Access Compliance Report

Public Rights-of-Way

Intersection ID: 18216	Main Street: FOREST_DR	Cross Street: S_WENDOVER_RD	Location: W
ADA ID: 3596CBAF8090	Ramp Type: BlendTrans2	Initial Pass/Fail: Pass	Overall Compliance: No
		Severity Score: 0

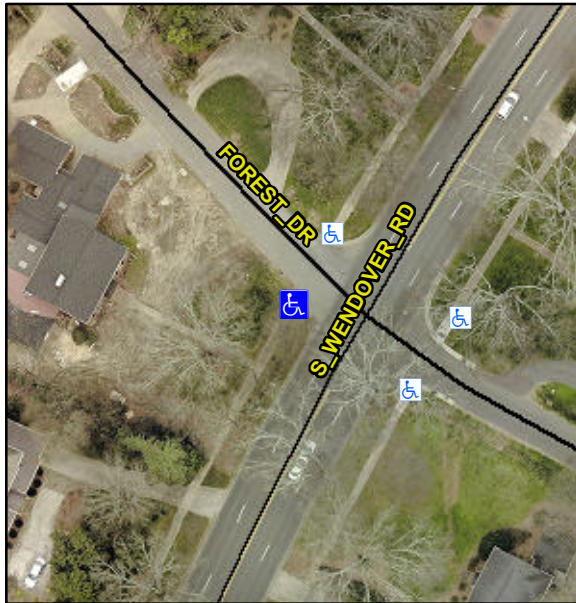
Surveyor Notes:

ASP LIP 0.5

PROW/ADA:

Not Found, R305.2

Possible Solutions:

Remove & Replace Curb Ramp With Two New Directional Ramps or Equivalent.
